R66 SERVICE BULLETIN SB-11

SUBJECT: Tail Gearbox Sight Gage

ROTORCRAFT AFFECTED: R66 helicopters S/N 0002 thru 0541, 0547, and 0551.

FIGURE 1

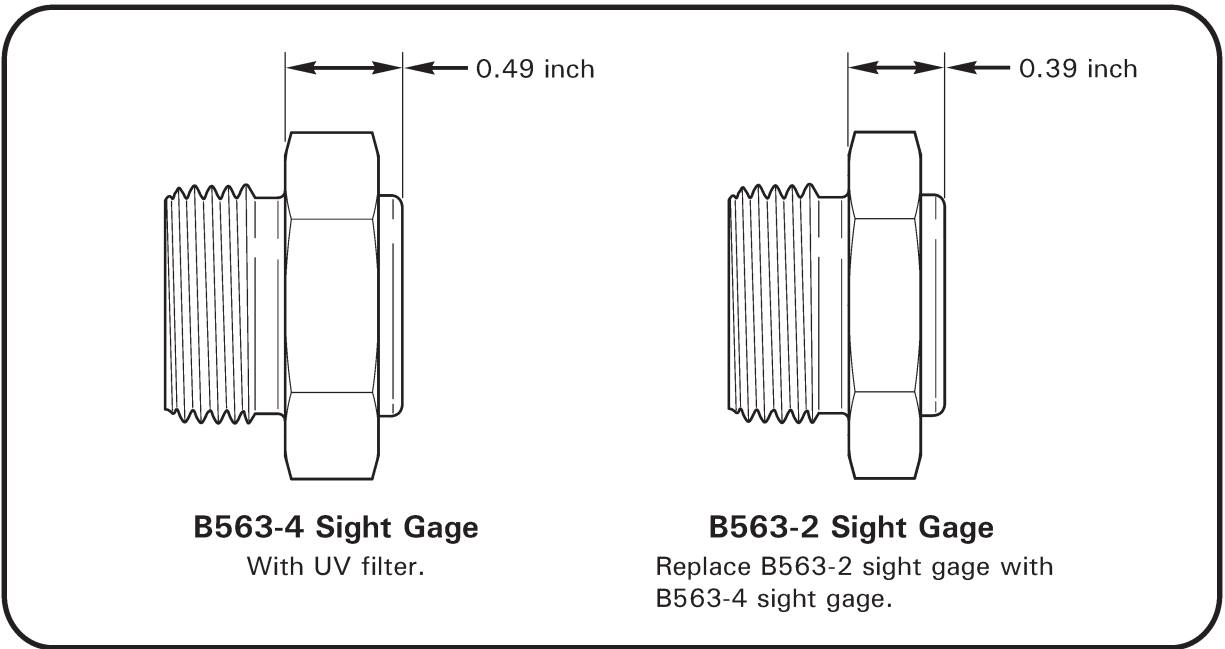
BACKGROUND: RHC has received reports of A257-22 oil staining the tail gearbox sight gage glass after exposure to direct sunlight. Stained glass can result in a false level indication. This bulletin requires replacing earlier gages with a B563-4 sight gage which incorporates an ultraviolet (UV) light filter which prevents staining due to sunlight.

1. Refer to Figure 1. If B563-4 sight gage (with UV filter) is installed, the requirements of this bulletin have been complied with. Proceed to step 5.
2. If B563-2 sight gage is installed, order one B563-4 sight gage and one A215-020 o-ring.
3. Remove sight gage per R66 Maintenance Manual (MM) § 12-22 Part A.
4. Apply A257-22 oil to new A215-020 o-ring and install on B563-4 sight gage. Install B563-4 sight gage per MM § 12-22 Part C.
5. Make appropriate maintenance record entries.
